### Addendum No. 02

**SUCF Project No. 221038-00**

**Renovate Pioneer Center**

**State University of New York College of Technology at Alfred**

## EXTERIOR LIQUID FILLED TRANSFORMER PAD DETAIL - SKE-01

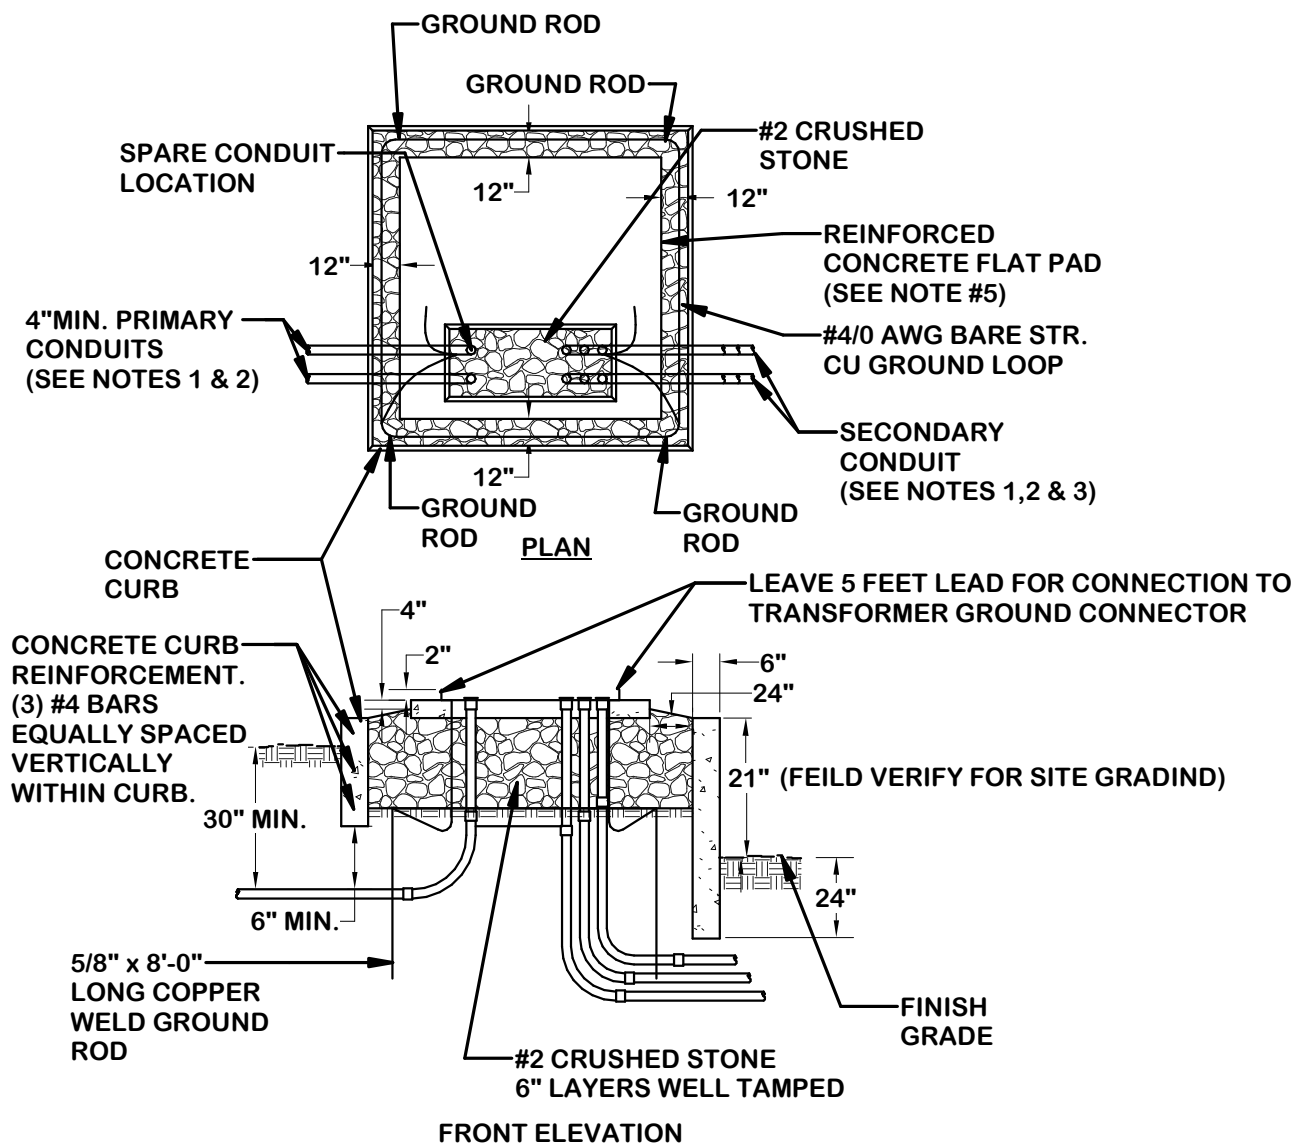
**Refer to:** *Drawing E-400 Electrical Details*

**Replace:** Exterior Liquid Filled Transformer Pad Detail 2/E-400 with attached Exterior Liquid Filled Transformer Pad Detail 1/SKE-01

Ref. Description: REVISED DETAIL 1/E-400
